September 23, 2021  
Staff Report to the Baldwin Park  
Town Review Design Committee

CASE #MPL2021-10046  
Item #4

## GABLES MULTI-FAMILY DEVELOPMENT MASTER PLAN

ARCHITECTURAL  
SITE PLAN

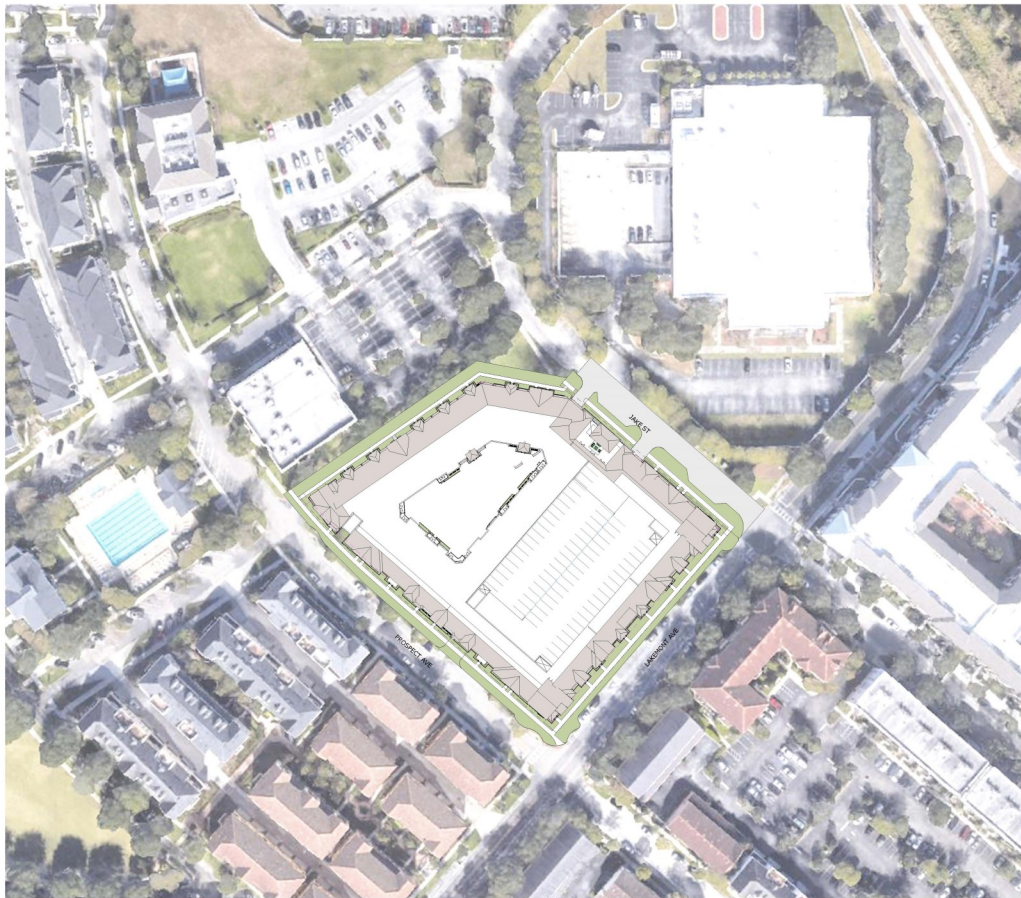
The proposed multi-family development will be bounded by Prospect Ave. to the SW, Lakemont Ave. on the SE, an Orlando Urban District owned driveway to the NE and a privately owned property to the NW. The applicant is proposing to utilize the existing street network to provide access to the project site and are proposing a single entry to the parking garage off the driveway on the NE side of the site with a pull through service/loading zone also located off the driveway. While there is a clear desire by both staff and the applicant to minimize the views of parking and vehicular use areas within the Baldwin Park PD, a secondary access point is required to support the number of proposed units. Given the site layout, topography and desire to minimize the impact of the second curbcut staff recommends that the second access point be placed along Prospect Ave.

4. A bulb out must be constructed at the north east corner of Lakemont Ave. and Prospect Ave.
5. A second access point to the garage must be provided in accordance with the LDC. This second access point must be the be at the location of the A1 unit directly between Prospect Ave. and the garage ramp.

EW SECTION  
SCALE: 1/8" = 1'-0"  
NOT FOR CONSTRUCTION

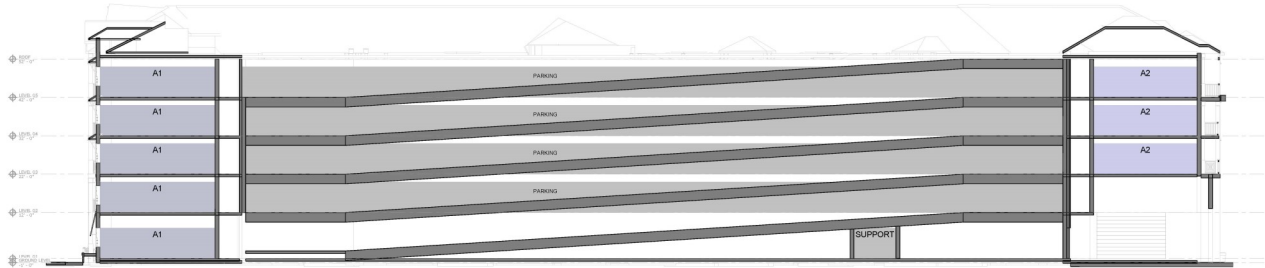
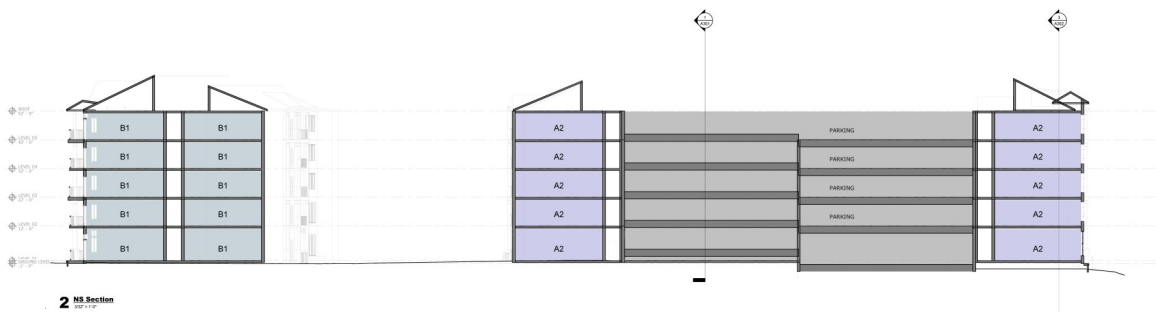
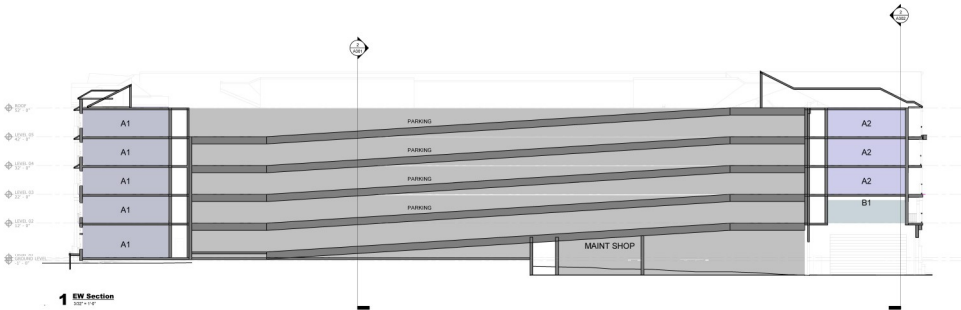
Building Height: (Minimum height is 2 story, Maximum 5) The Village Center General requires a minimum building height of 2 stories with a maximum height of 5 stories but does not include any regulations for maximum height in feet. As proposed the applicant is seeking to build 5 fully-occupiable floors. The site gradient causes the first floor living level to be approximately 9 feet above the level of the sidewalk at the corner of Lakemont and Jake and while there are only 5 occupiable levels, the building has the mass of a 6 story building at this location. The height of the building is noted to be 58'-6" with the highest roof ridge at 68'-6" not including any grade changes. The PD defines Story as “That portion of a building included between the surface of any finished floor and the surface of the next finished floor above it, or if there be no floor above it, then the space between such floor and ceiling next above it, unless such space is less than 5.5 feet in height. Wherever the height between two finished floors (or finished floor and ceiling) exceeds 25 feet, each height of 15 feet or portion greater than 5.5 feet thereof shall construed to be a story.” So technically by the definition the foundation area below the living level does not count as a story. The massing and scale is affected by the grade change as the roof height at the corner of Lakemont and Jake would be approximately 77'-6" above the sidewalk.

3. **Retaining Wall Height at SE Corner:** The applicant shall continue to explore additional ways of mitigating the height of the first living floor along Prospect and Lakemont Avenues, especially at the corner of Lakemont and Jake. A single 9 foot high retaining wall is not acceptable. The materials of the retaining wall shall include stone or brick rather than stucco alone.
